July 11th, 2025

The following is a written document to respond to the comments issued by the Design Review Board of the City of Miami Beach under file number **DRB25-1115**, in regards to the new construction to be located on 900 S Shore Dr (lot 10) Miami Beach, FL 33141. Architect's answers are in **bold**:

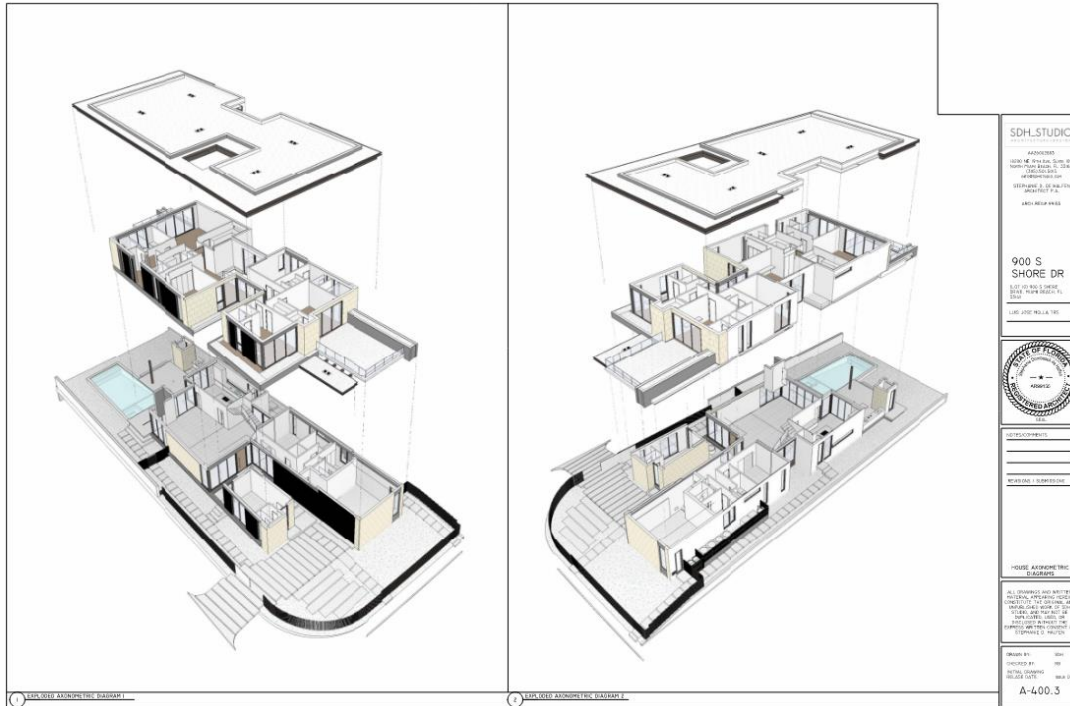
a. Add "FINAL SUBMITTAL" and DRB File No. to front cover title for heightened clarity.

R= Front cover has been updated.

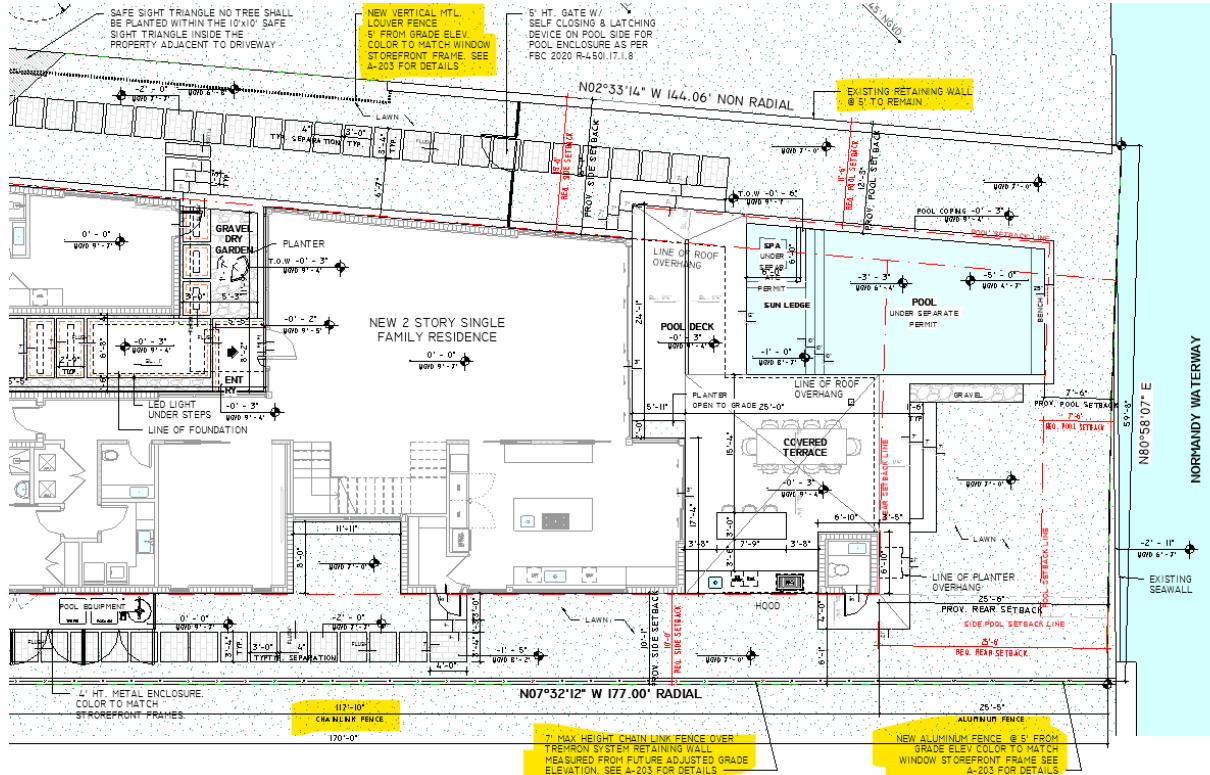
d. Site plan/first floor plan: Retaining walls/fences: Demonstrate compliance with Section 7.2.2.3.b.12.H. Provide height and setbacks if applicable for the existing/proposed walls on the required rear, side, side facing the street and front yard on the site plan. indicate where the new and existing walls stop/start. Provide separate detailed elevations for the proposed walls/fences/gates, provide height dimensions from grade, materials etc.,

R= Please see sheets A-100, A-202 and A-203 for the fences details.

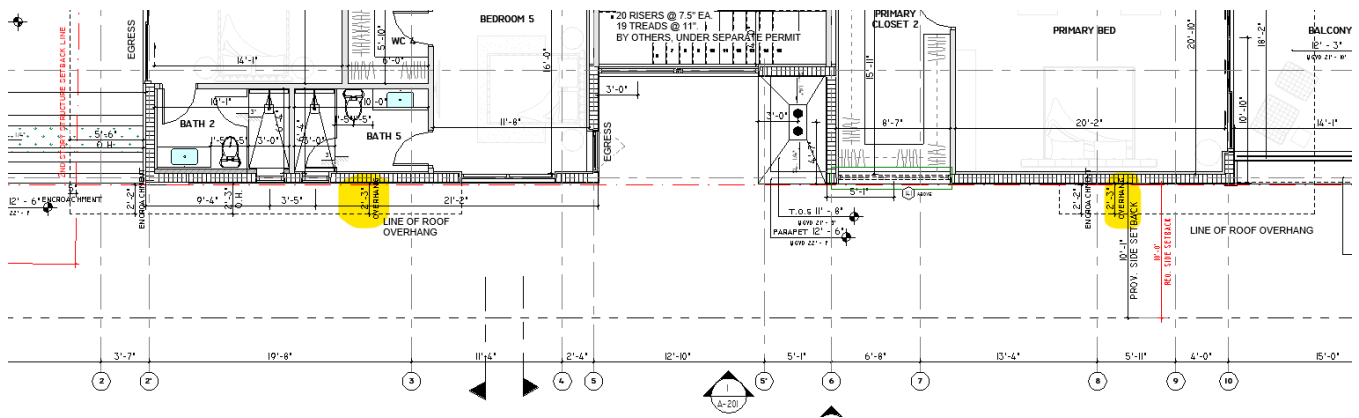
g. Projections: Portion of the roof overhang on the west side is projecting more than 25% of the required setback. Revise and provide dimension.

R= Please note that the overhangs were updated. Refer to sheet A-102 and A-103.

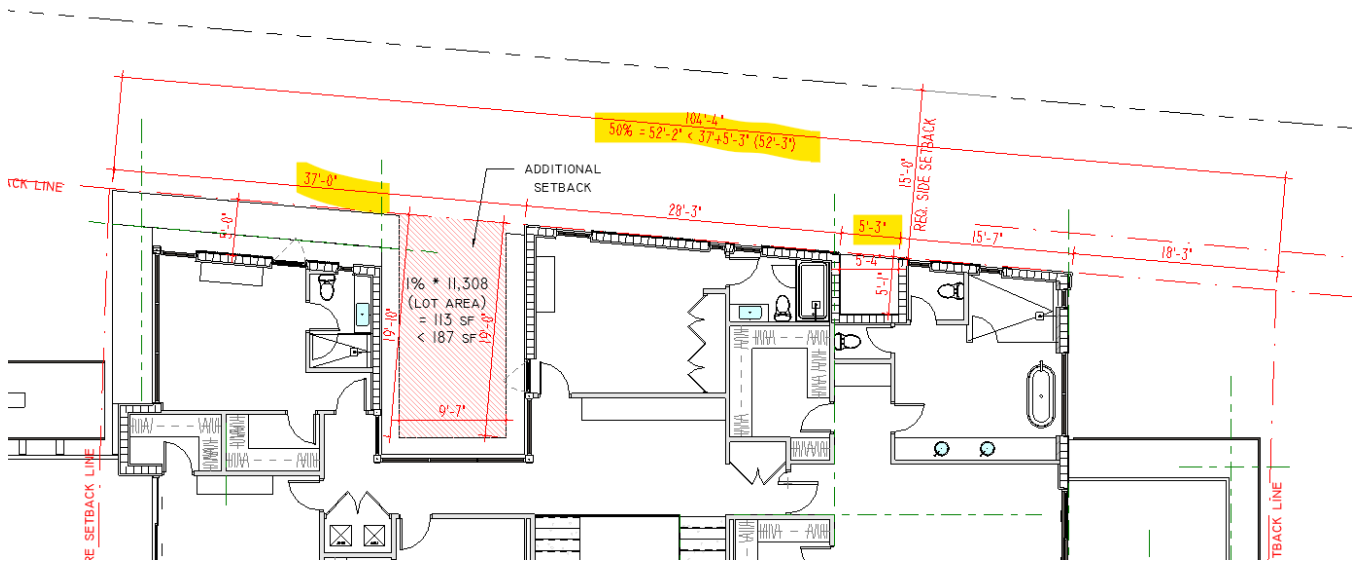
h. All allowable exterior walkways and driveways within the front and street side yards shall consist of pavers set in sand or other semi-pervious material. The use of concrete, asphalt or similar material within the required front or street side yards shall be prohibited. Provide the pervious paver finish of the driveway in the site plan.

R= Noted, please refer to sheet A-100 where the materiality of the driveway and walkways have been updated.

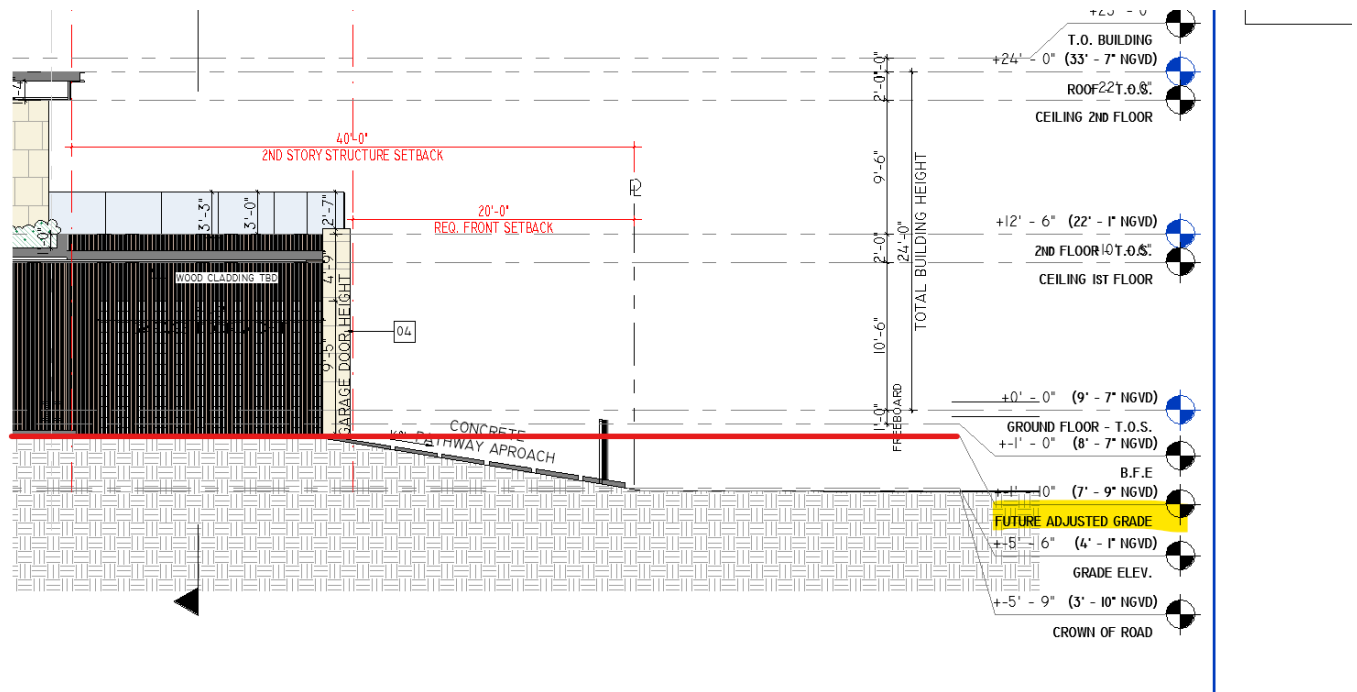
l. The minimum yard elevation is future adjusted grade. Future adjusted grade means the midpoint elevation between the future crown of the road and the base flood elevation plus minimum freeboard for a lot or lots. Provide written confirmation from the Public Works Department that identifies the future crown of the road for further review of compliance the minimum yard elevation.

R= Please see attached the email from public works where the Future Crown of Road was specified. The yard elevation is the future adjusted grade.
